LAKE COUNTY FOREST PRESERVES

ADDENDUM NO. 2

INVITATION FOR BID NO. 18001

SPRING BLUFF OBSERVATION PLATFORM

PIER LOADING PLAN

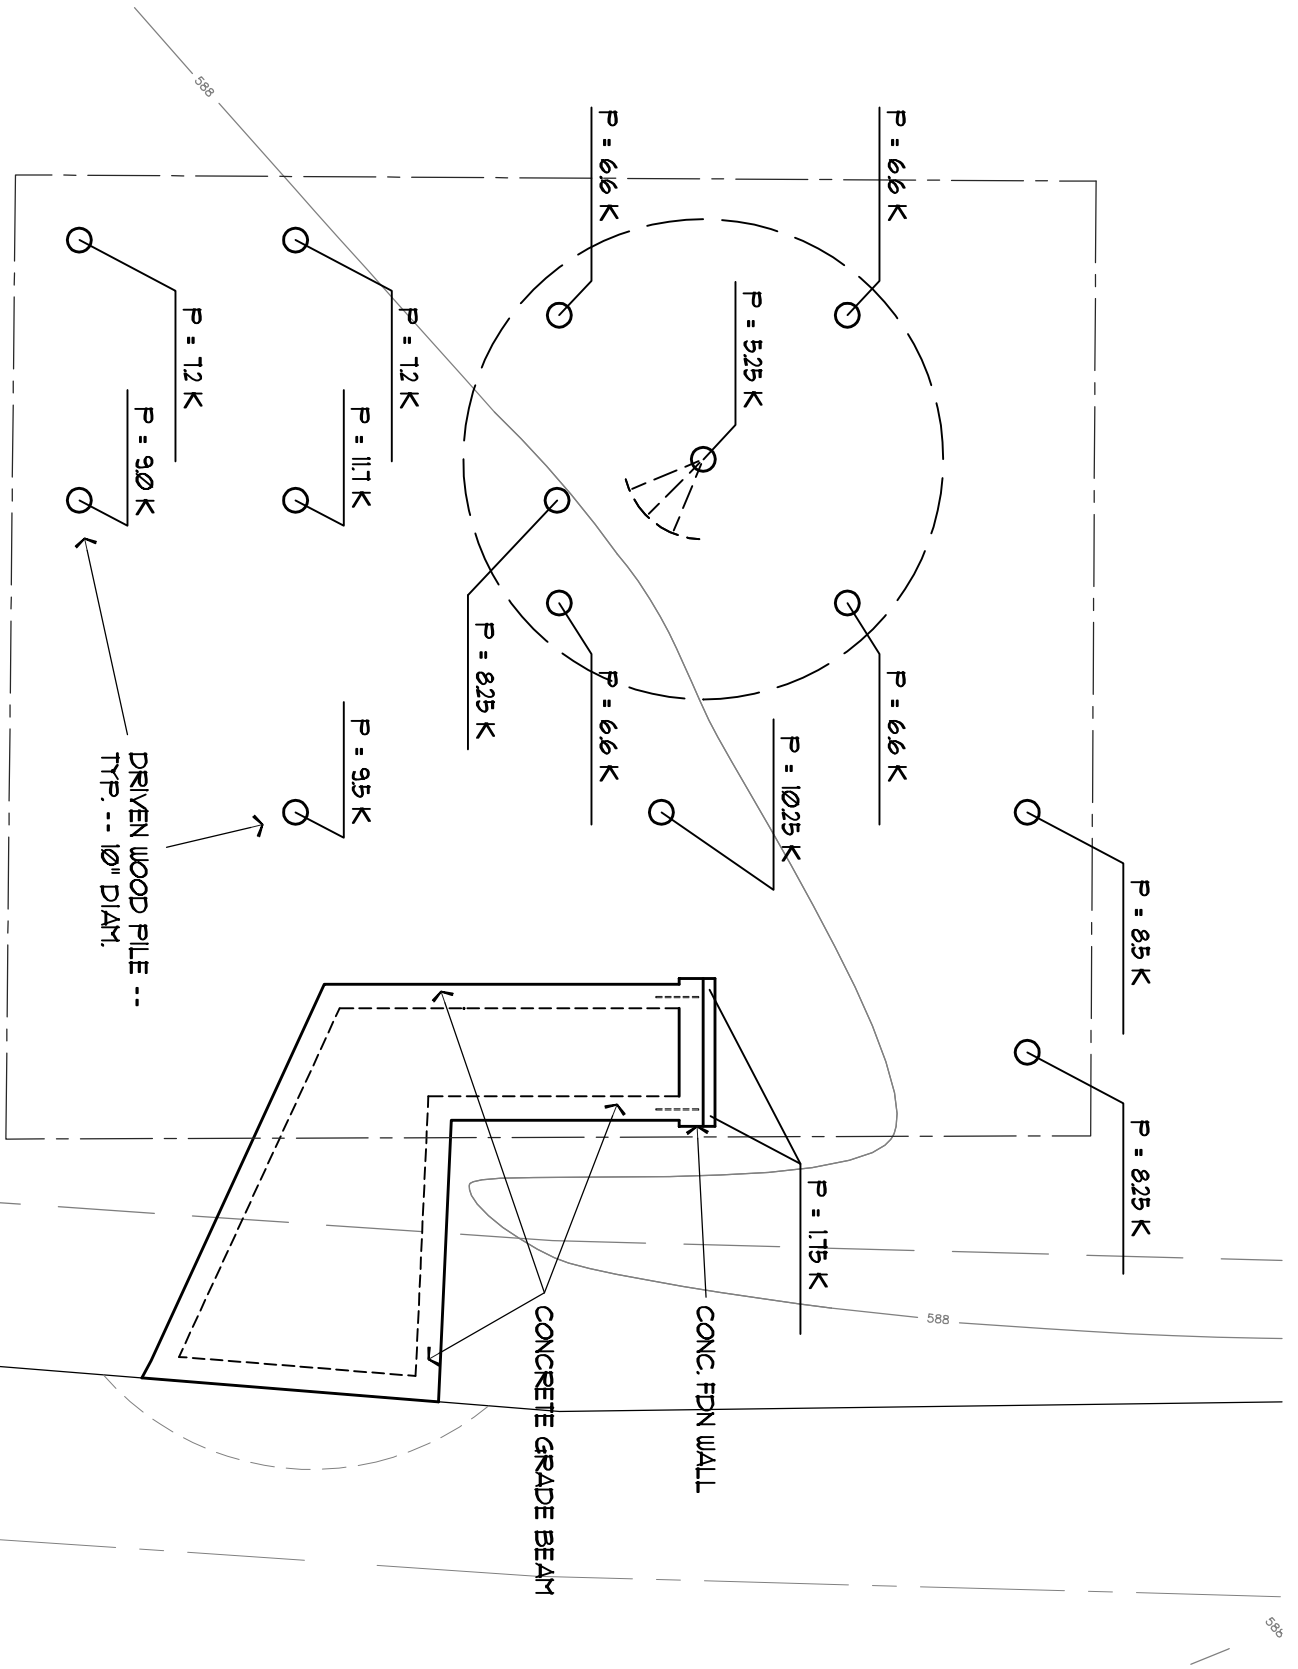
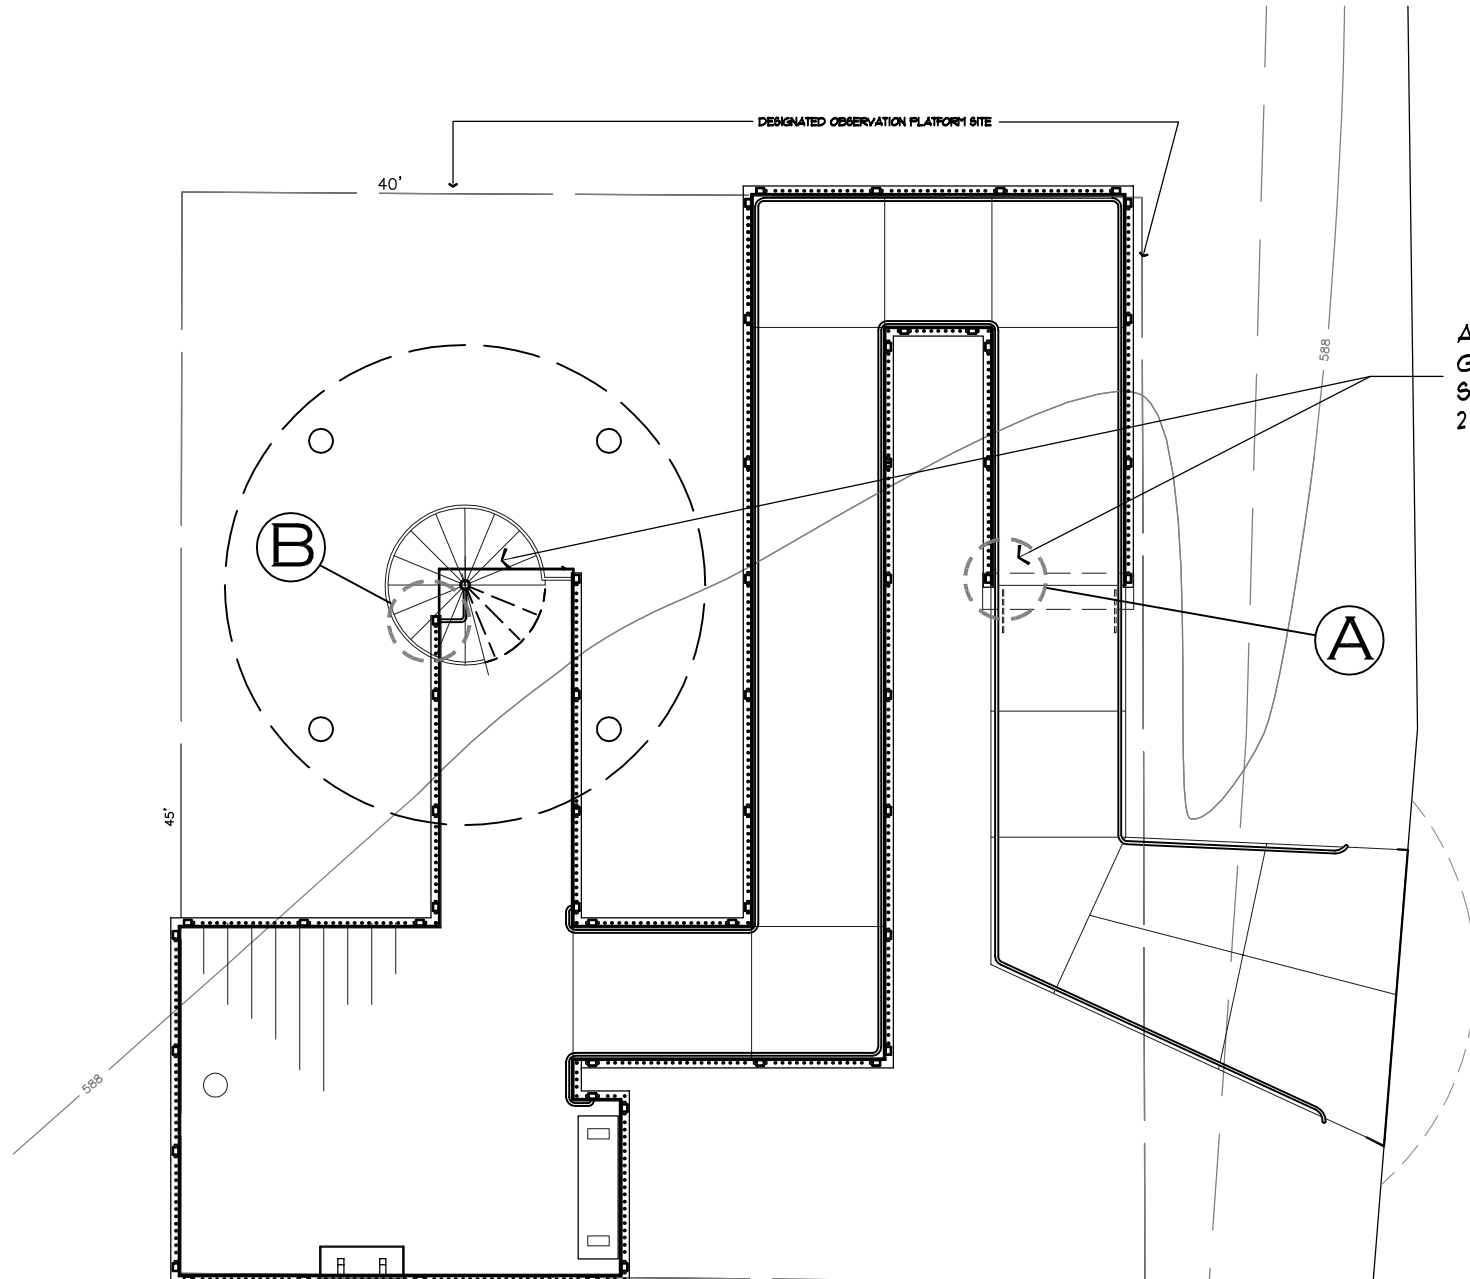
3. QUESTION: Do you have any loading information? I can assume from the nominal capacity shown in the geotech report that each pile has a 20 Kip design load, but I would like to be sure. I would also like to know if we need to design for lateral or uplift loads.

ANSWER: See drawing, "ADD-2.1 Pier Loading Plan". The design accommodates lateral and uplift loads.

ADD-2.2
NOVEMBER 3, 2017

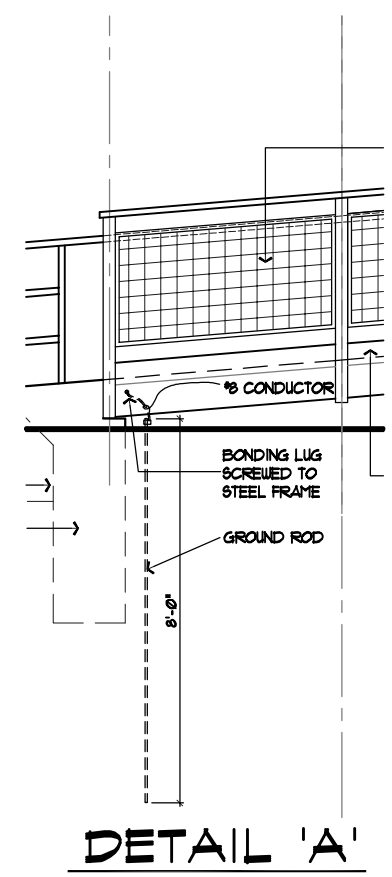
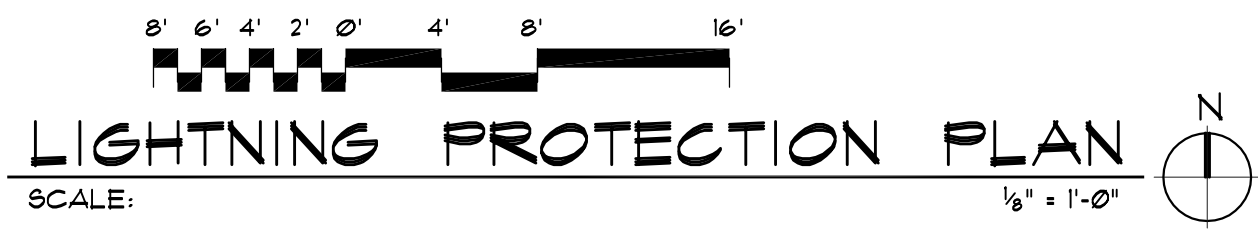
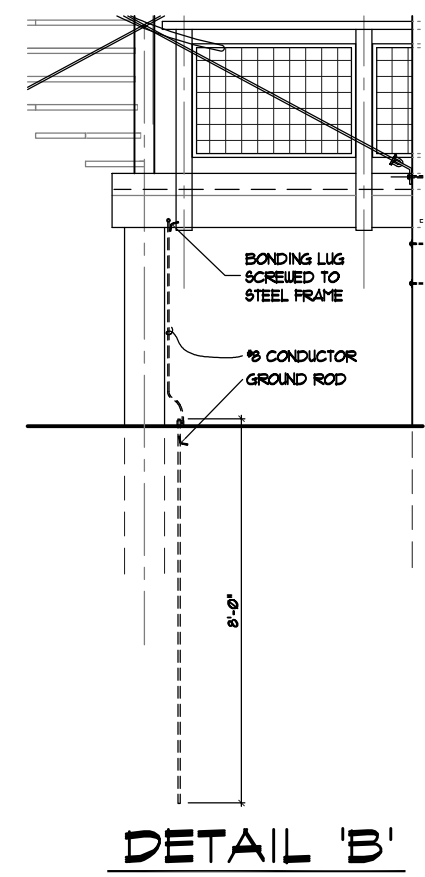
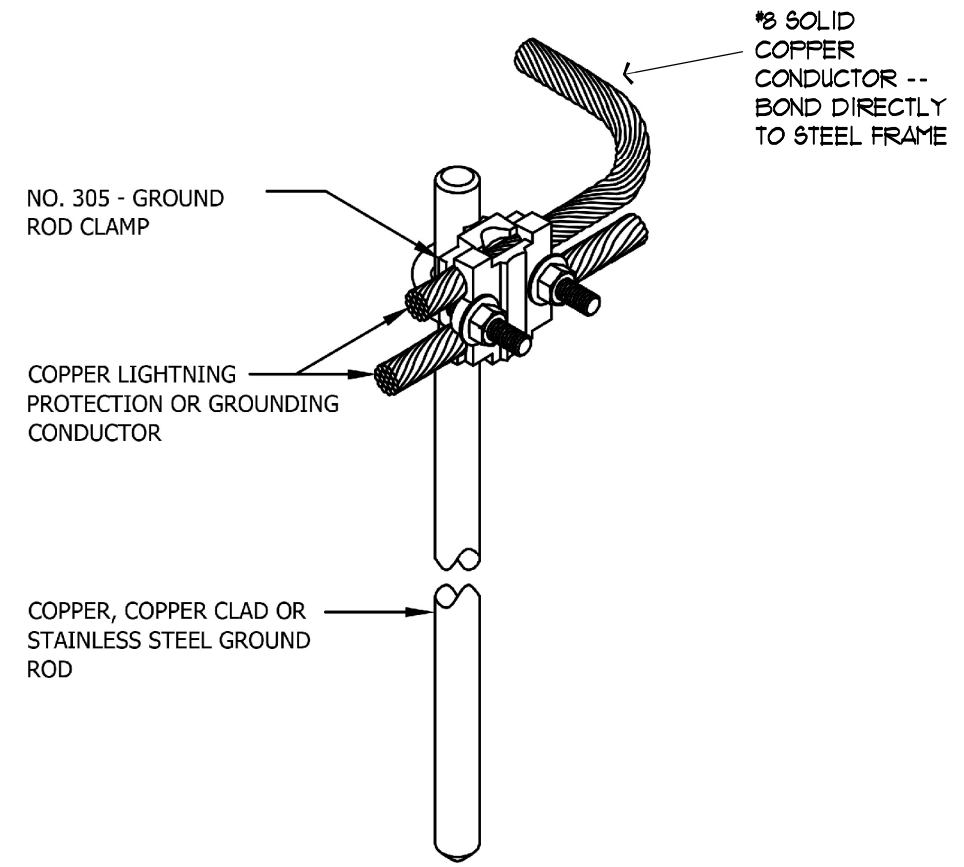
2. QUESTION: Please provide a specification and drawing for the lightning protection system.

ANSWER: See drawing, "ADD-2.2 Lightning Protection Plan"

ATTACH 8' LONG GROUNDING ROD TO STEEL STRUCTURE @ 2 LOCATIONS
